Clark’s meeting follow-up

Select a question to read the response and supporting detail. Pricing stays in Blake’s separate sheet.

Nine cost requests

Five confirmations

IGS C02, detail 1. Elevation reference only. Hoist closure location and lifting plan pending.

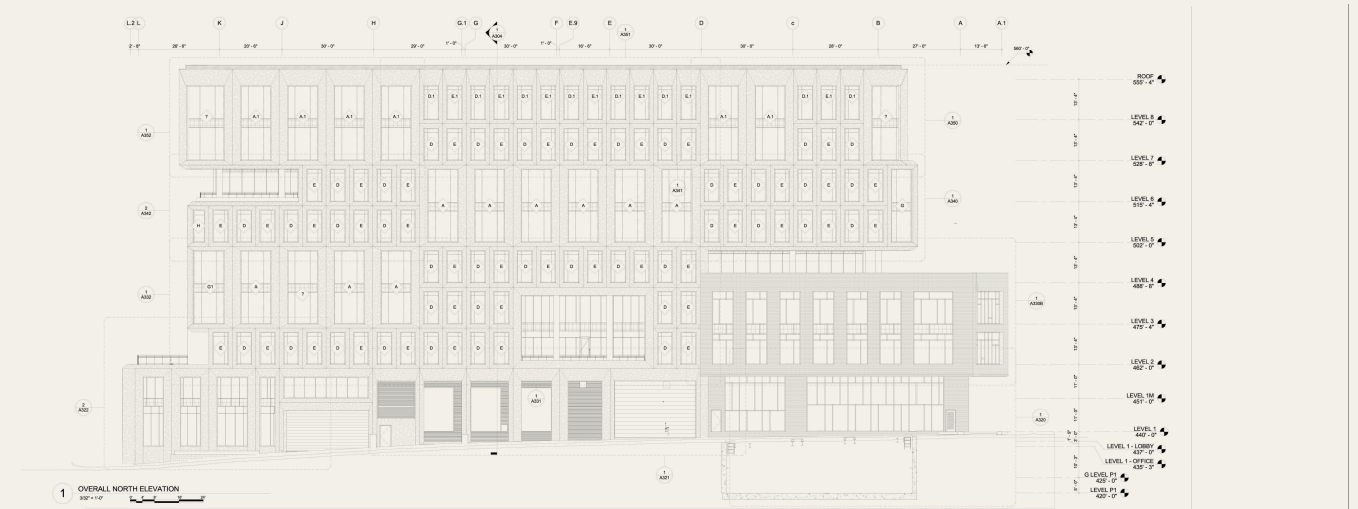
Closing the facade at the hoist requires a lift plan based on the closure sequence, pick weights and reach. The available tower-crane provisions do not establish a dedicated closure-crane quote. Operations and the crane supplier need to confirm the equipment, duration and access requirements.

- Confirm closure date, pick weights, reach and lift duration.
- Quote mobilization, rigging, operator, permits and traffic control.
- Reconcile any hoisting or return-work allowance already carried.

VISION MULLION PAIR
SCALE: 1'-0" = 1'-0"

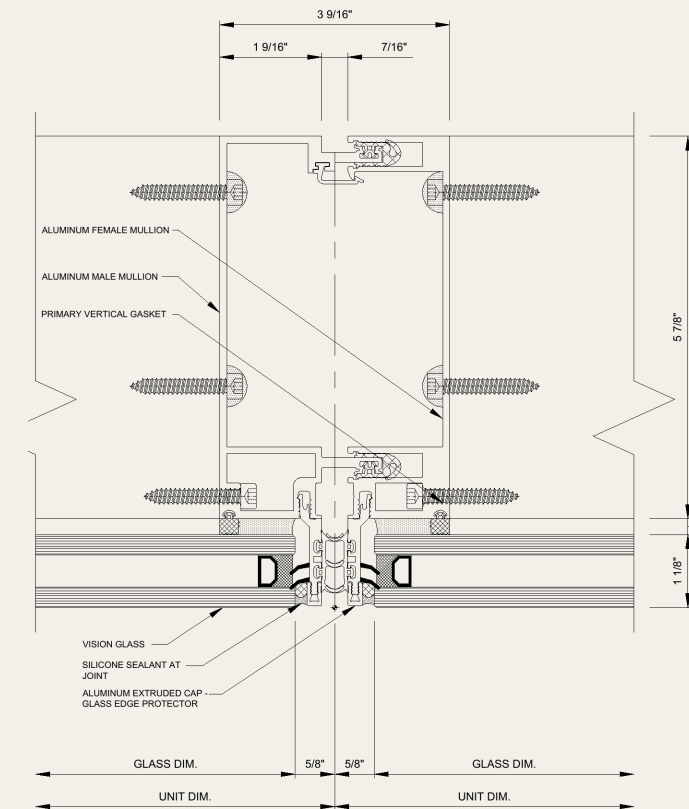
Clark's request covers all tempered glass, including any tempered plies within laminated units. IGS and the glass fabricator need to confirm the complete lite schedule, heat-soak procedure and certification. The five replacement pieces must be coordinated with this scope to avoid duplicate treatment charges.

- IGS to identify every tempered lite and confirm treatment coverage.
- Provide the procedure, traceability and certificates.
- Quote the premium and schedule effect. Avoid overlap with the five replacement pieces.

IGS C02, detail 3. Current elevation reference. Three-door revision pending.

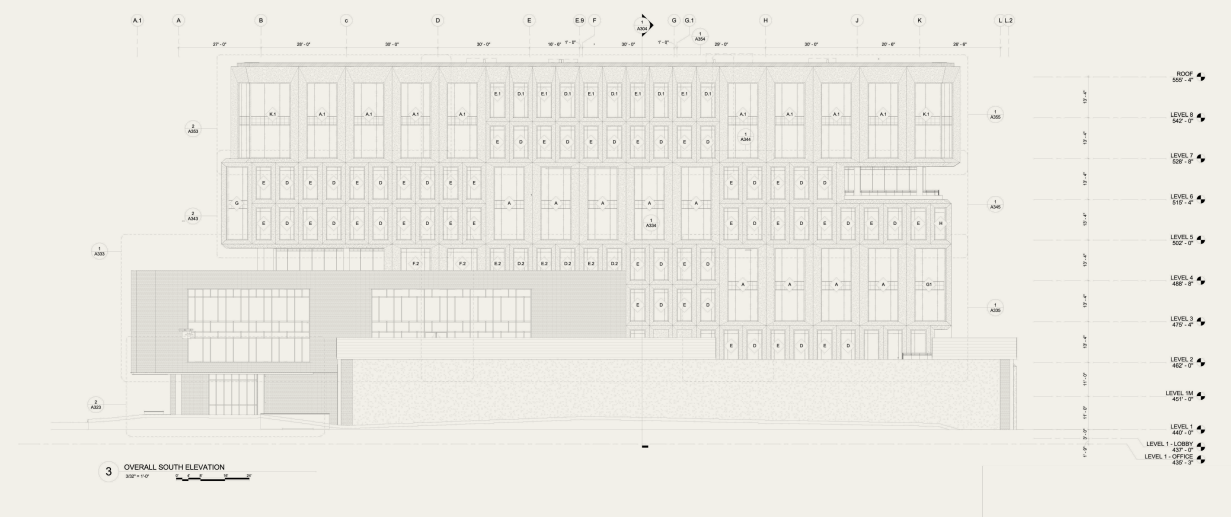
The requested Level 6 change is three terrace doors instead of one: two additional complete assemblies. Keep the original door in the base scope and coordinate the additional frames, hardware, finish, installation and facade interfaces. Revised locations, dimensions and hardware still require supplier confirmation.

- Price two additional doors with frames, specified hardware and finish.
- Include installation, seals and facade interface work.
- Keep the existing door in the base scope. Confirm schedule impact.

IGS SD106, detail 3. Glazing-joint reference only. Replacement-piece schedule pending.

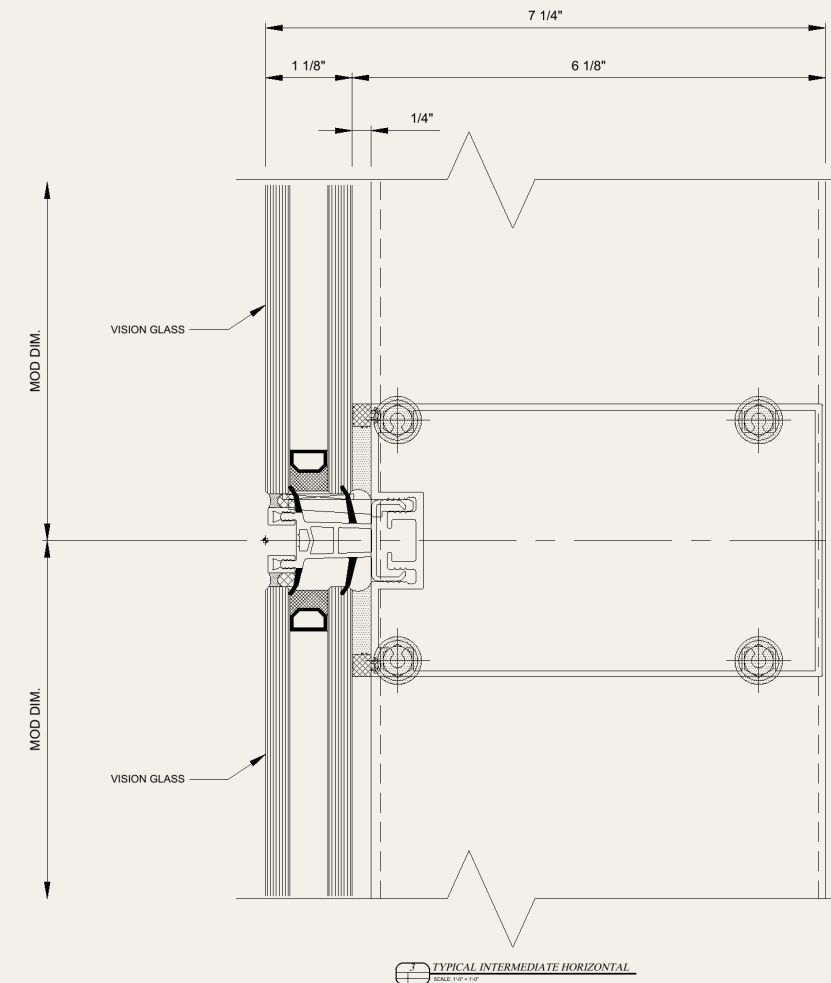
The requested replacement quantity is five glass pieces. A piece schedule is needed to identify locations, dimensions, glass build-ups and access conditions. The installed scope should cover fabrication through replacement and sealing, with heat soaking coordinated under the all-tempered-glass request.

- Issue a five-piece schedule with dimensions and glass specifications.
- Price fabrication, transport, removal, access, installation and seals.
- Coordinate heat soaking with C02 to prevent duplicate charges.

IGS SD101, detail 1. Window-profile reference. Stool-trim detail pending.

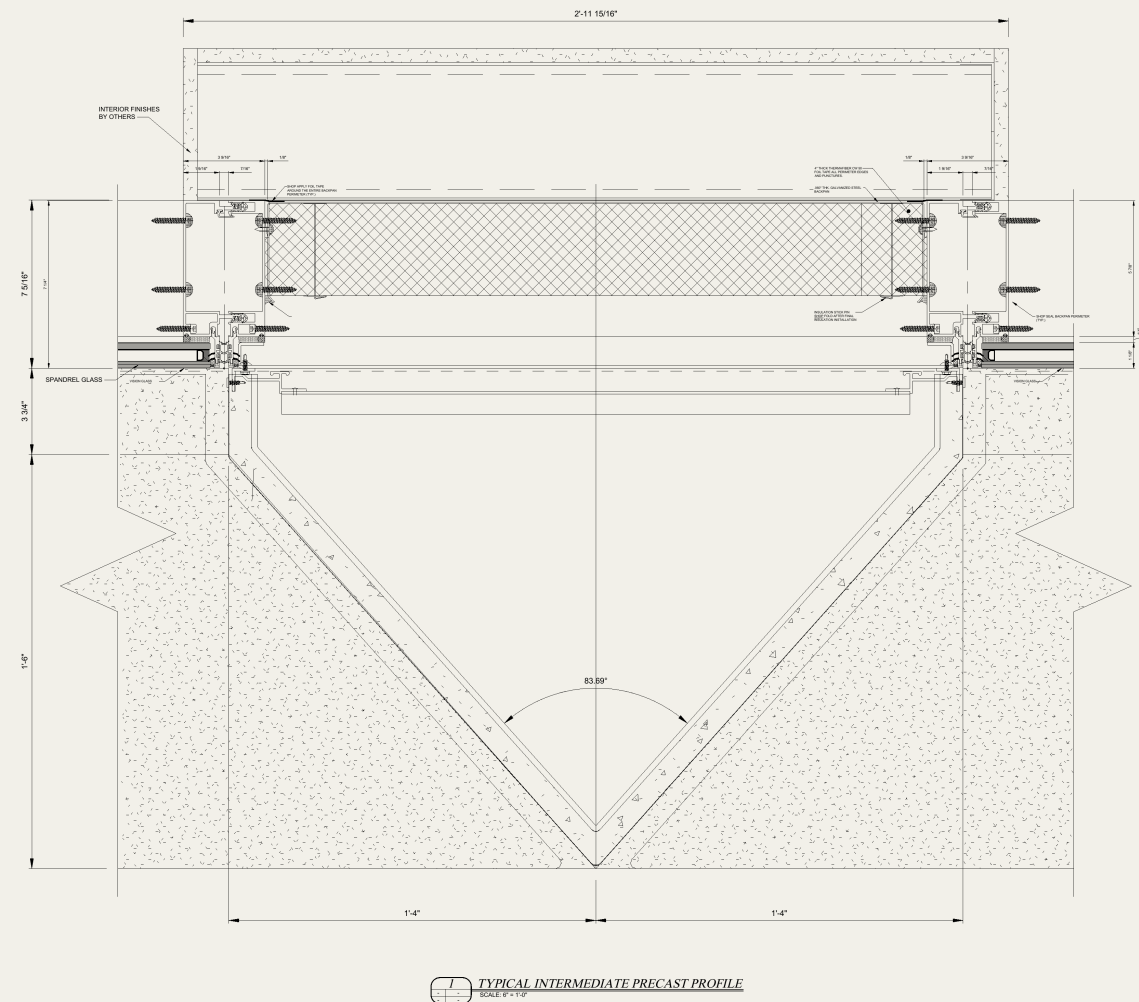
The stool-trim scope needs an agreed profile, material, finish and measured quantity. IGS's window section provides coordination context, but it does not establish a complete stool-trim detail. Confirm the trim interfaces and installation responsibility, and reconcile any sill or interior trim already included.

- Confirm the trim detail, extents and interface responsibilities.
- Price fabrication, finish, attachment, joints and installation.
- Reconcile any sill or interior trim already carried.

RFI 8, original annotated elevations. These are design priorities, not an approved revised joint layout.

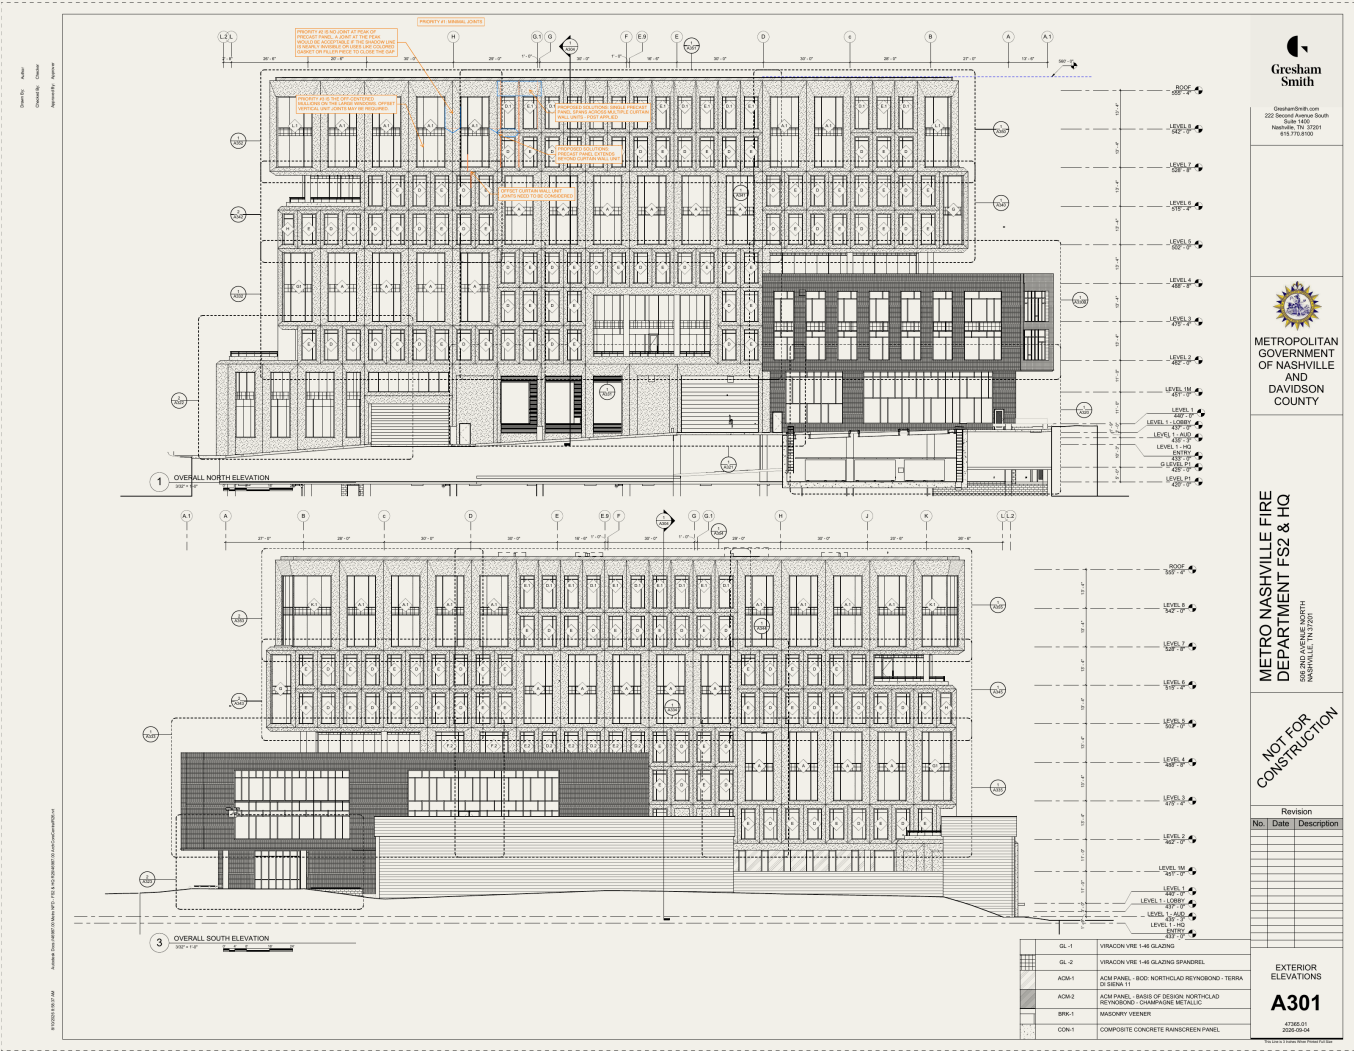
RFI 8 prioritizes fewer joints, avoiding joints at panel peaks, and the large-window mullion arrangement. IGS needs to return feasible options by location after confirming the proposed panel material and attachment system. The Keil note concerns sealing anchor holes; it does not establish approval to bond panels together.

- Show joint locations, nominal widths and the response to each RFI priority.
- Confirm bonding feasibility, movement, support and warranty implications.
- Price each feasible option with its engineering and schedule effects.

IGS SD104, detail 1. Panel-section reference only. This is not a shipping-rack or hoist-clearance drawing.

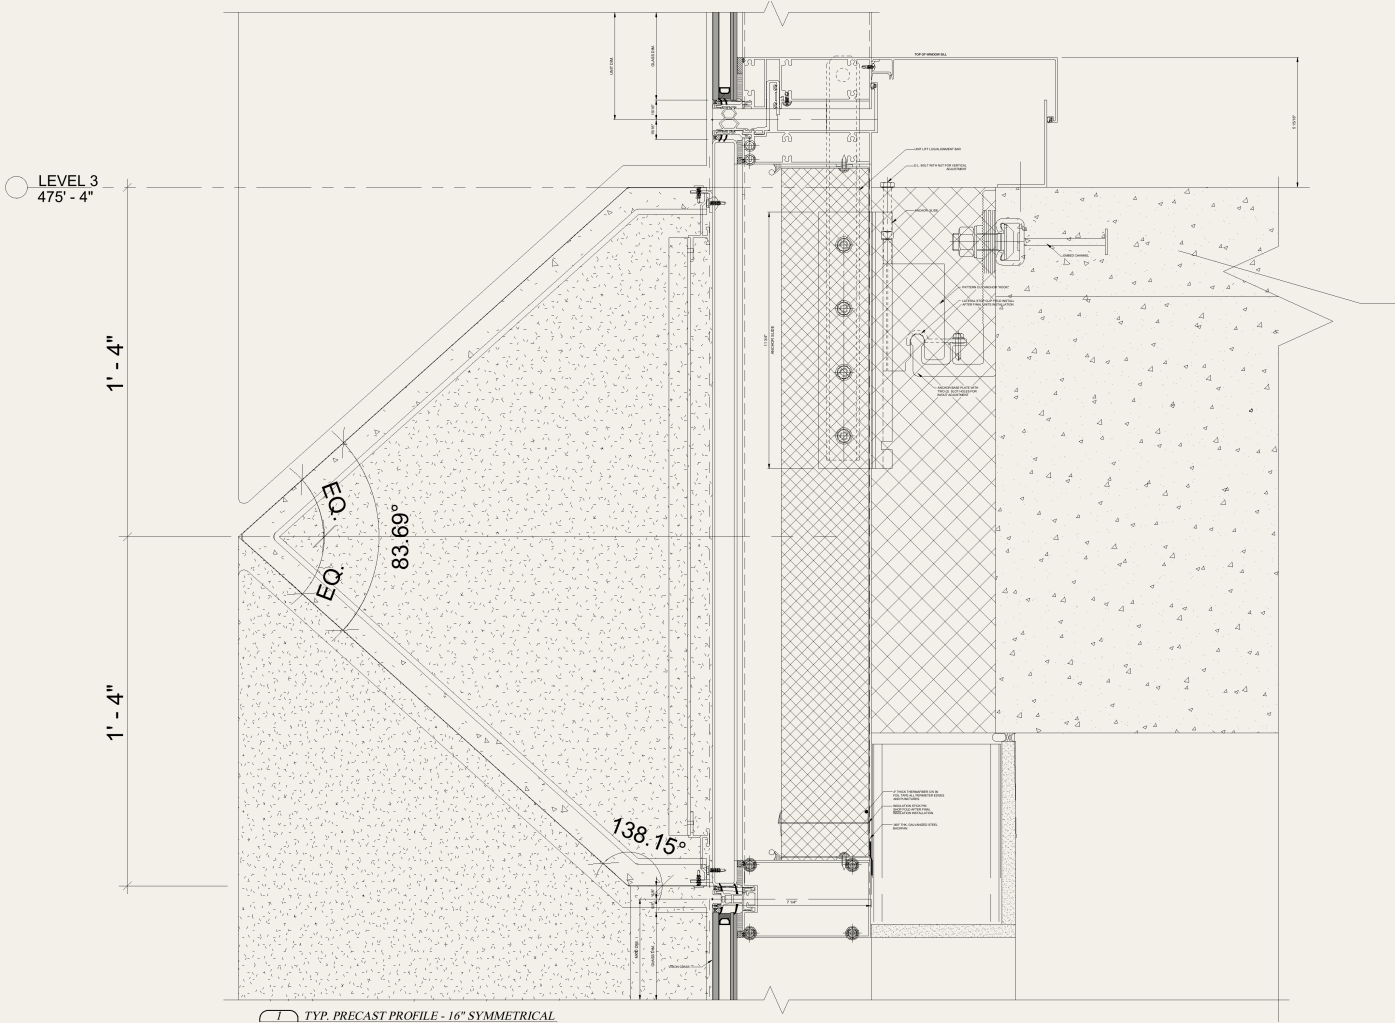
Hoist sizing must follow the largest packed unit, including the rack, weight and handling clearance. IGS needs to provide that packing information so operations can state minimum and preferred cab dimensions, clear opening and capacity. Those requirements must then be checked against Clark’s actual hoist.

- IGS to provide the largest packed dimensions, weight and unloading method.
- Operations to state minimum and preferred cab, opening and capacity.
- Check the requirement against Clark’s actual hoist data.

IGS SD106, detail 1. Typical stack joint. A detail does not replace the requested marked elevations.

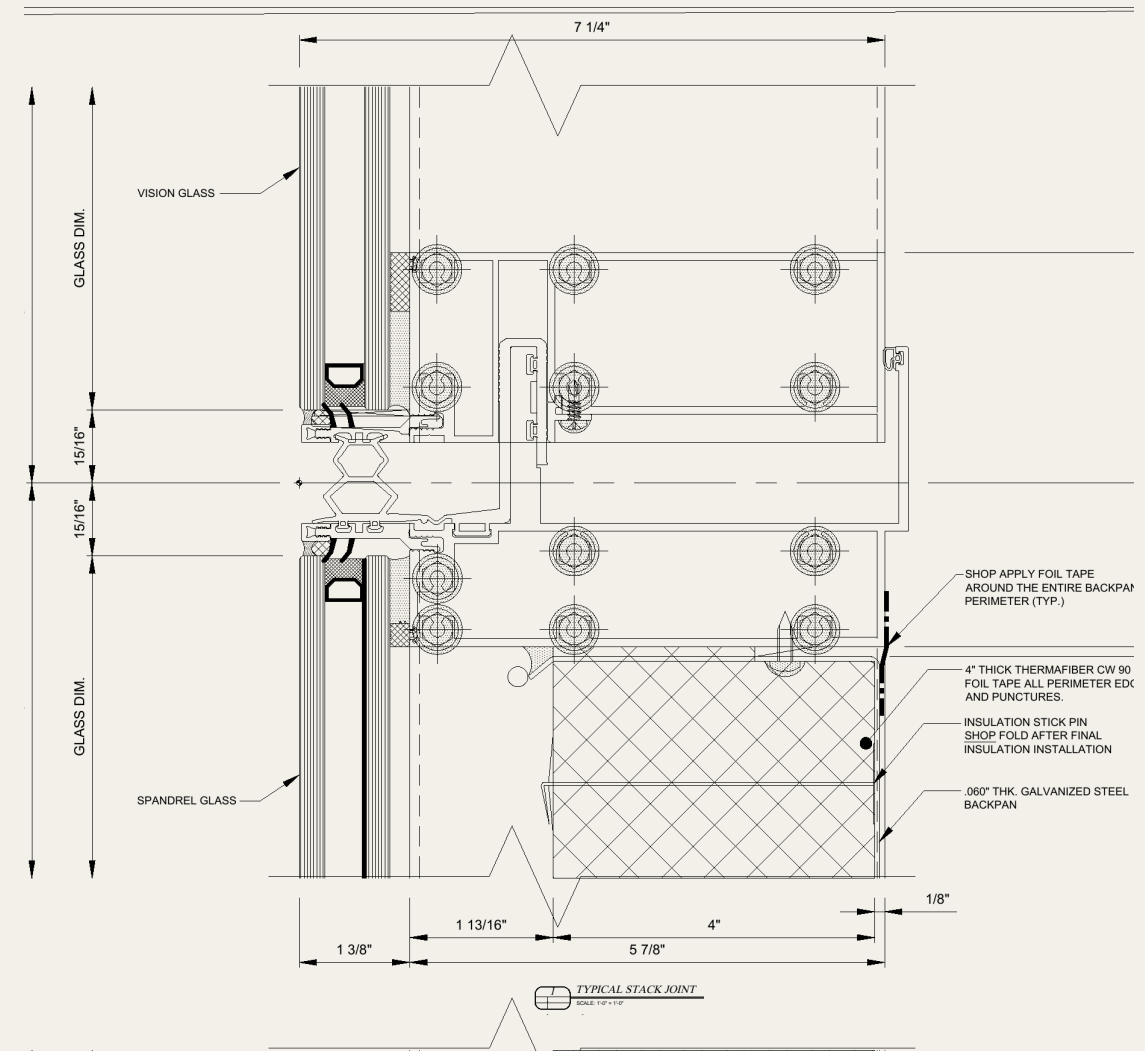
The existing IGS sections show typical connections, but Clark needs a coordinated elevation marking each proposed joint and its nominal width. Include panel peaks, large-window offsets, stack joints, corners and perimeter transitions. Key the sections and any joint-reduction options to those locations.

- Mark panel peaks, large-window offsets, stack joints, corners and perimeter transitions.
- Label joint types and nominal widths using the confirmed material system.
- Tie joint-reduction options to the RFI priorities and premium in C09.

2 SPANDREL MULLION PAIR
SCALE: 1'-0" = 1'-0"

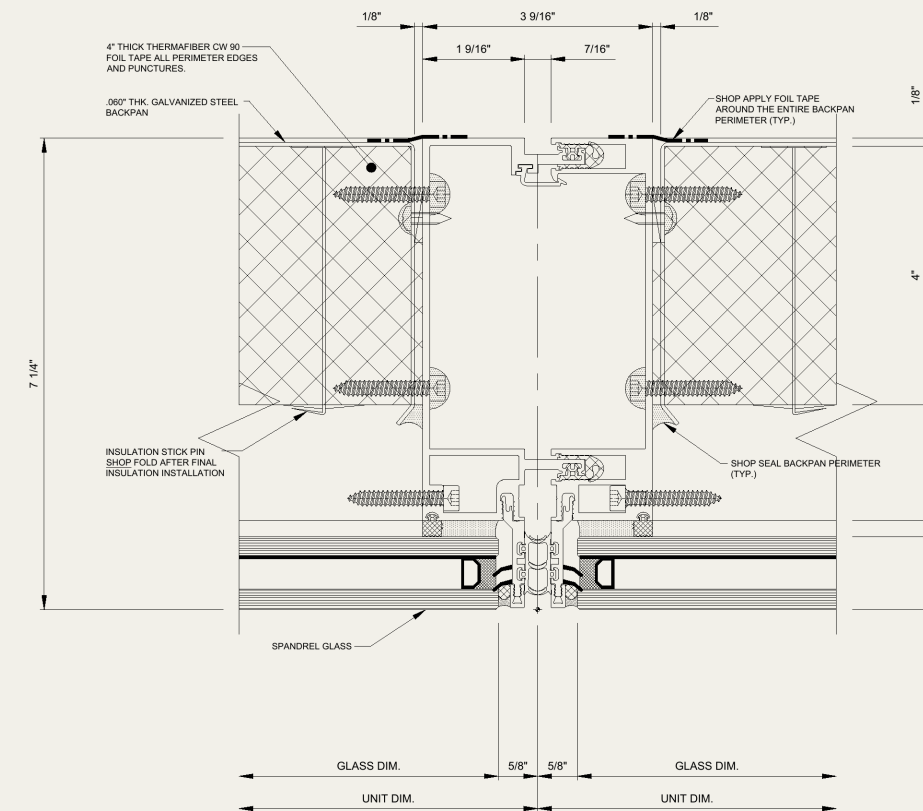
The IGS spandrel detail identifies 4-inch Thermafiber CW90 insulation and a .060-inch galvanized backpan. Those component descriptions do not establish the complete facade's R-value or U-value. IGS must provide documented values for the actual vision and opaque/spandrel assemblies, with units, configuration and calculation or test basis.

- IGS to provide the actual assembly configuration and calculation / test basis.
- Include units, glass / coatings, framing and insulation in the response.
- Separate component and whole-assembly values. Dekton expansion data does not establish wall insulation performance.
